**COUNTY OF SANTA BARBARA
PLANNING AND DEVELOPMENT
MEMORANDUM**

Subject: Revised Materials for October 6, 2009 Hearing: Santa Ynez Valley Community Plan

FIGURE 15
Santa Ynez Valley Community Plan
Parks, Recreation & Trails

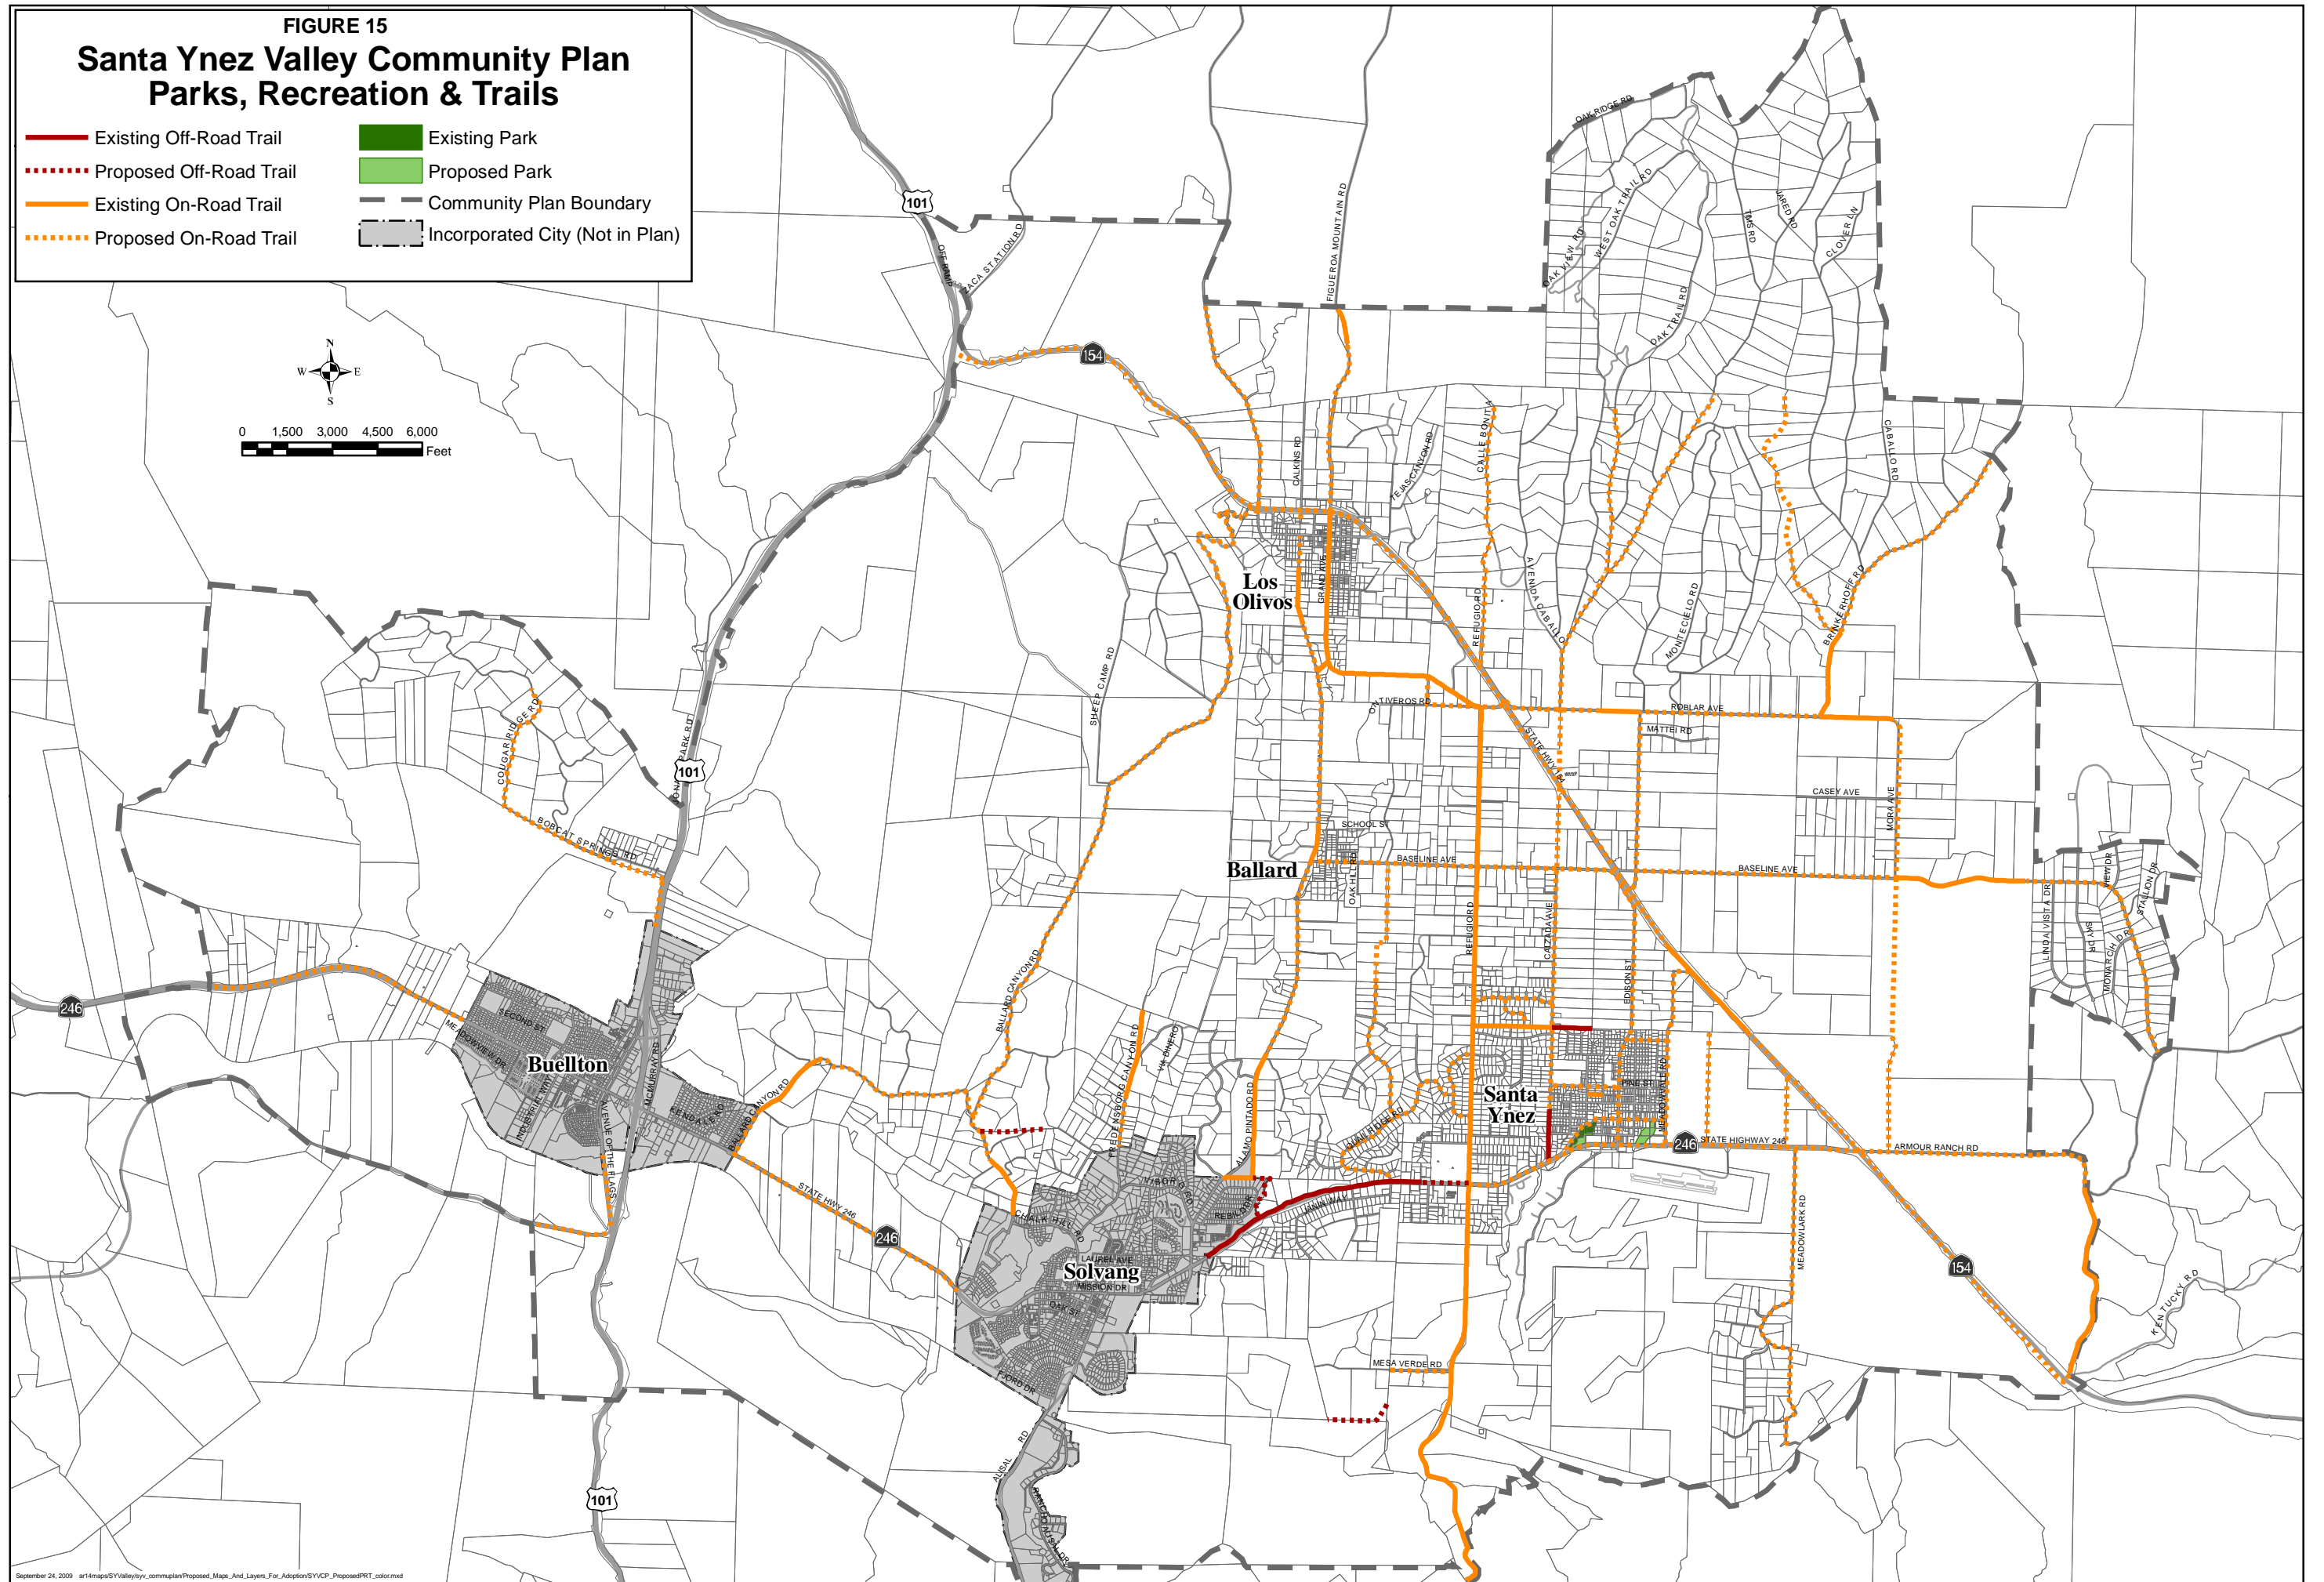
1. Parks, Recreation, and Trails (PRT) Map – The previously distributed PRT maps are inconsistent with the Planning Commission recommended PRT map. The attached map replaces board letter Exhibit 2 of Attachment E, Comprehensive Plan Land Use Element Resolution and Figure 15 of the proposed Final Santa Ynez Valley Community Plan.
2. Development Standard Language (Dev Stds. LUT-SYV-5.2 & 5.3) – The previously distributed recommended development standard language is incorrect. The attached language replaces board letter Attachment L, Proposed Revised DevStd 5.2 & 5.3 Language: Structural Setbacks and Landscape Buffers.
